DEVELOPMENT ASSESSMENT REPORT				
Application No.	DA/2021/0491			
Address	8/28 Gower Street SUMMER HILL NSW 2130			
Proposal	Enclosure of an existing balcony by the installation of windows			
Date of Lodgement	16 June 2021			
Applicant	Mr Warwick V Sinclair			
Owner	Owners of Strata Plan 89767			
Number of Submissions	N/A			
Value of works	\$22,000.00			
Reason for determination at Planning Panel	Exceeding the maximum allowed FSR by more than 10%			
Main Issues	Impacts on streetscape, bulk and scale, loss of amenity			
Recommendation	Refusal			
Attachment A	Reasons for refusal			
Attachment B	Plans of proposed development			
Attachment C	Conditions of consent (if approved)			
Attachment D	Statement of Heritage Significance

This report is an assessment of the application submitted to Council to carry out the enclosure of a balcony to residential unit 8 of 28 Gower Street SUMMER HILL NSW 2130.

NEW WINDOWS TO
EXISTING BALCONY
SCALE 1:50

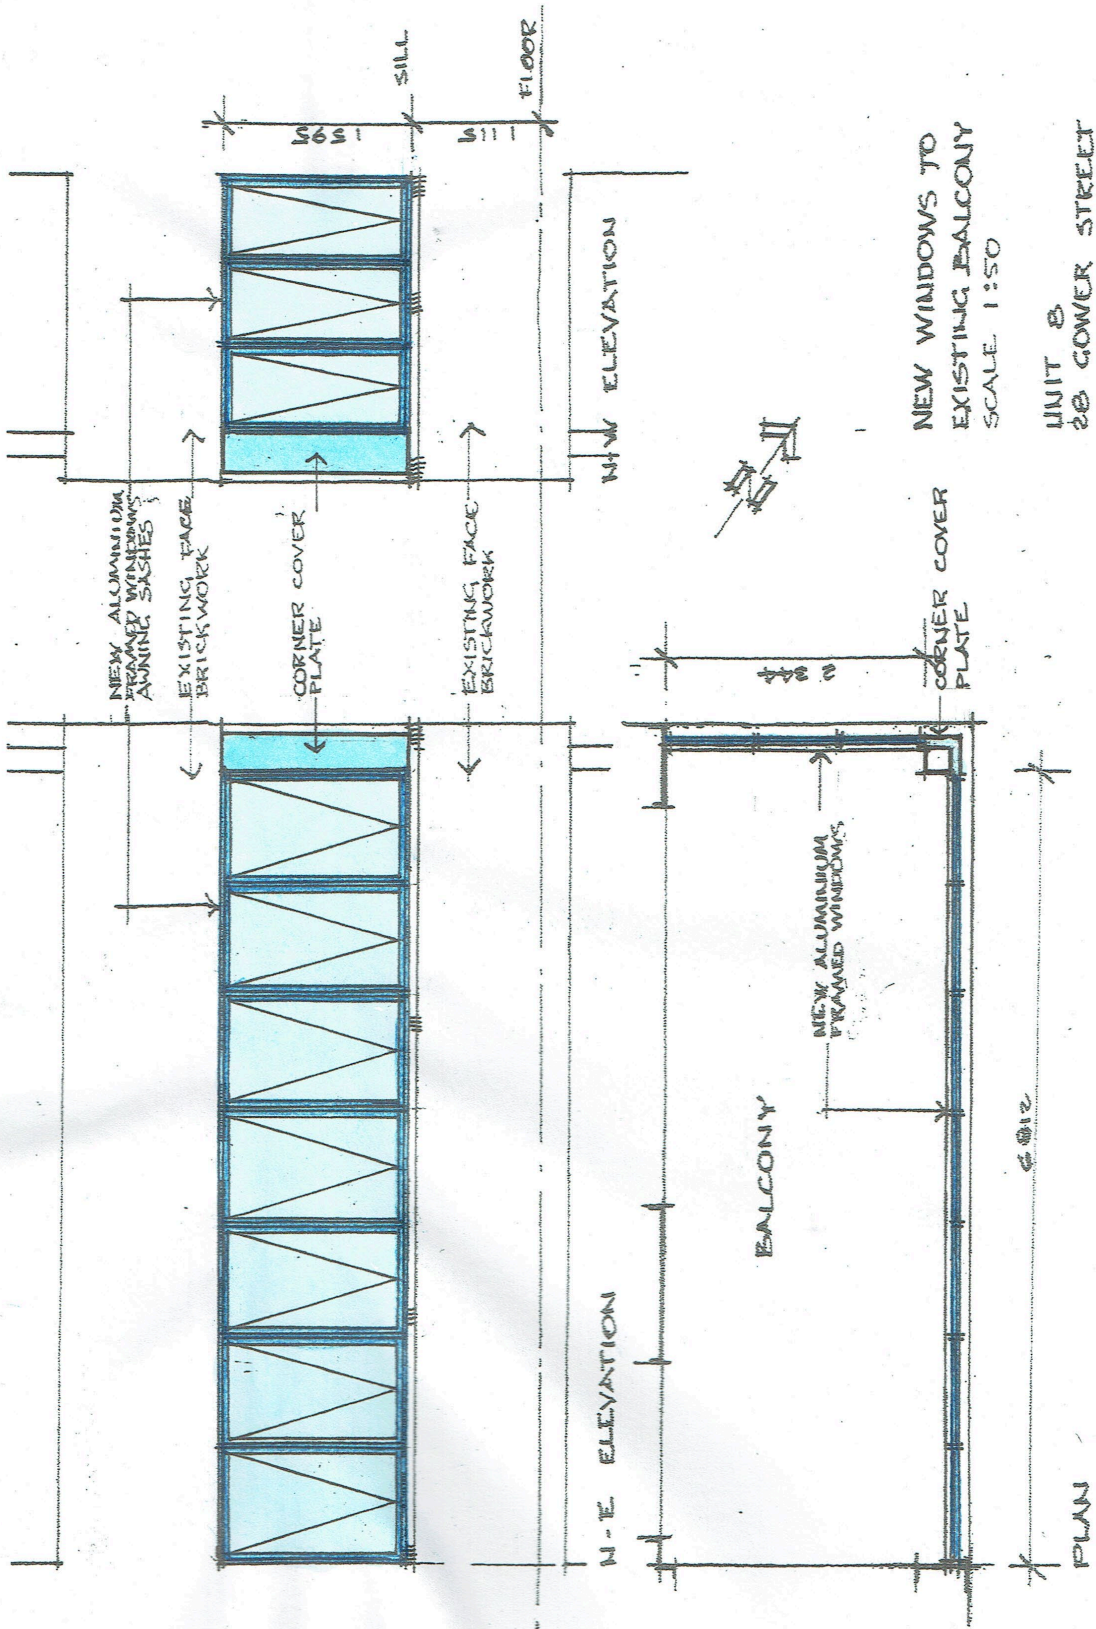
- Comment: Although the proposed windows are clear aluminium windows that will match the existing windows in the building the enclosure of the balcony will have a negative impact on the streetscape and is inconsistent with the form and style of the residential flat building.

- Comment: The owner reasons for the development is to block out traffic noise. The proposal will result in the length of the living room increased to 10m. Natural light and ventilation for the existing living room and bedrooms will be borrowed from the enclosed balcony which is not an acceptable method of ventilating a room under the Apartment Design Guide (ADG). See ADG compliance table below.

- Comment: There are 78 residential units in the building complex with many relying on balconies for private open space. Enclosing the balcony will remove the private open space off the living area and have a detrimental impact on the streetscape and amenity of the residential unit. Enclosure of the balcony will reduce natural ventilation

- Comment: The applicant states that new windows will match the existing. The building faces Gower Street with balconies facing the street offering the only private open space for the residents of those units. The proposed development will be detrimental to the visual appearance of the building given that it will remove a desirable element being the open balcony. The balcony add to the visual appeal of the building as such its removal is not supported. See ADG compliance table below.
